Remarks

SERIAL NO. 09/649,559

Reply to Office Actions of 10 May 2004 & 18 Nov. 2004

FIG. 2

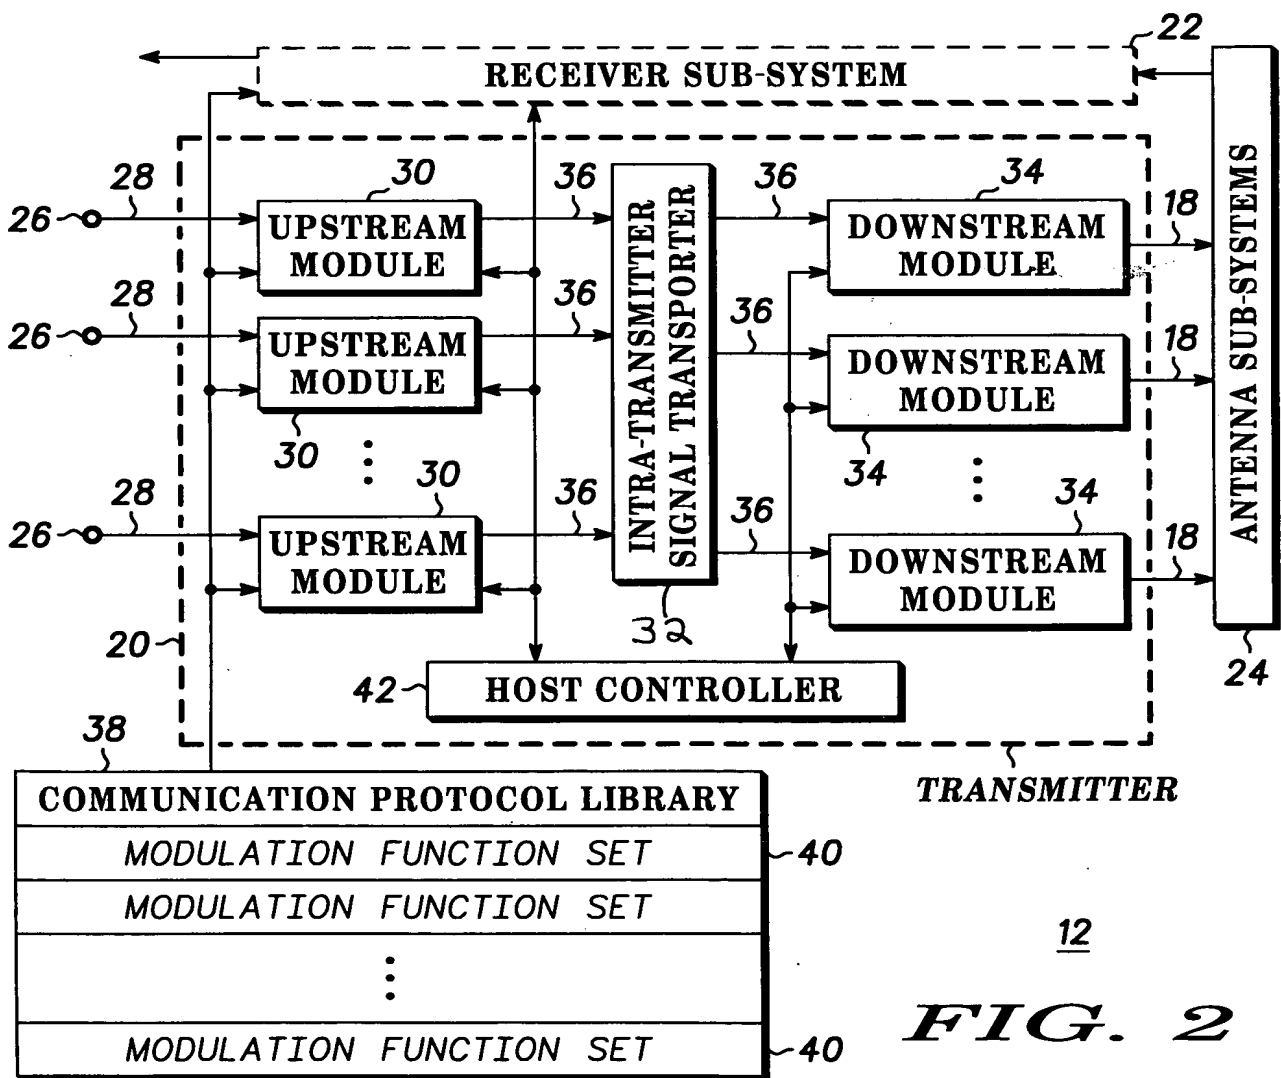
Section 1 on page 2 of the 10 May 2004 Office Action objected to Fig. 2 due to the omission of reference number "32". The amendment to the drawings herein corrects this omission. Accordingly, applicants believe this objection has been overcome.

The Appendix hereto includes changes to Fig. 2 on sheet 1 of 3 of the drawings. In particular, the reference number 32 has been added in reference to the block labeled "INTRA-TRANSMITTER SIGNAL TRANSPORTER." Appendix A includes a marked-up sheet 1 of 3 which highlights the change to Fig. 2, along with a replacement sheet 1 of 3 and three copies of the same.
